From: [REDACTED]
Sent: Monday, June 12, 2017 4:40 PM
To: Germinario, Lena@Waterboards
Subject: Tent. Ammending Order NPDES Permit/ Lehigh Water Treatment?SC Co Zoning Hearing
Attachments: Lehigh Water Treatment Facility - Zoning Administrator Hearing - May 4

In regards RWQCB Tentative Orders Amending Order Nos. R2 2014-0010 (NPDES Permit CA0030210) and R2-2014-0011 (Cease and Desist Order), Lehigh Southwest Cement Company and Hanson Permanente Cement, Inc. Permanente Plant, Santa Clara County, I am attaching details of Santa Clara County Zoning Officer's recent May 4 review of Lehigh Water Treatment Facility that I request be incorporated in record for RWQCB Tentative Orders Amending Order Nos. R2 2014-0010 and 0011 in continuation of my 6/8 comment.

This Santa Clara County Department of Planning and Development Architecture and Site Approval, Design Review, and Grading Approval - 2250-17A-17DR-17G (Lehigh Water Treatment Facility) of a 159.42 acre site is deemed ancillary and accessory to the Cement Plant, and includes a 9,100 square foot building, on a pad which necessitates 2,976.6 cubic yards (CY) of cut and 2,220.9 CY of fill for building footprint and associated outdoor equ

Figure 2 – Site Plan

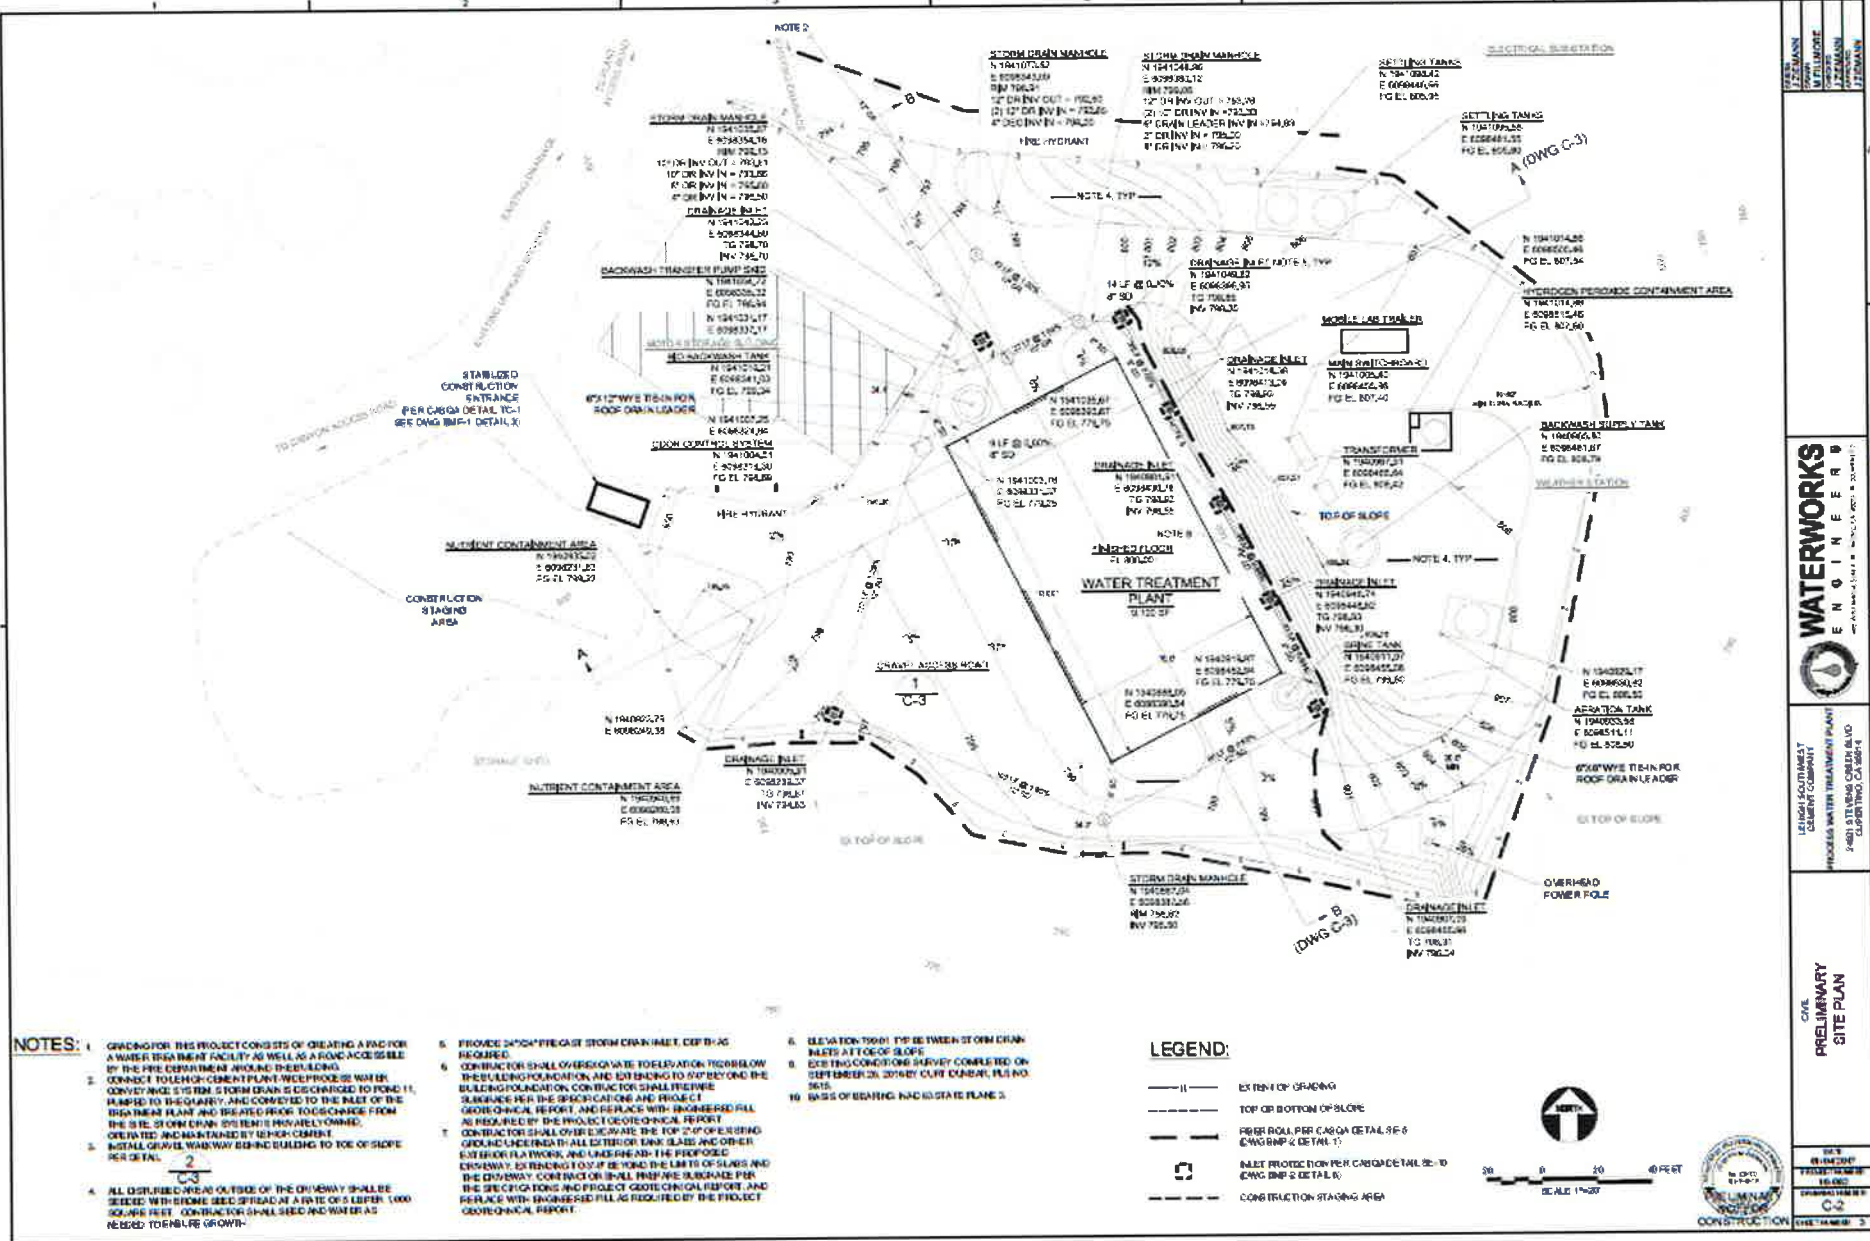
In recommended and approved plant design these tanks of chemicals are stored within building. The only outside tank shown is to store backwash' Proximity to earthquake faults demands special integrity in design.

In subsequent "Notice of Exemption from CEQA" of this attachment it amplifies facility auxiliary structures to include "several process water tanks..be installed on concrete pad foundations outside of building...tanks would vary in height from 8 feet to 22.3 feet" On page 2 of document "7 process water tanks to be installed".
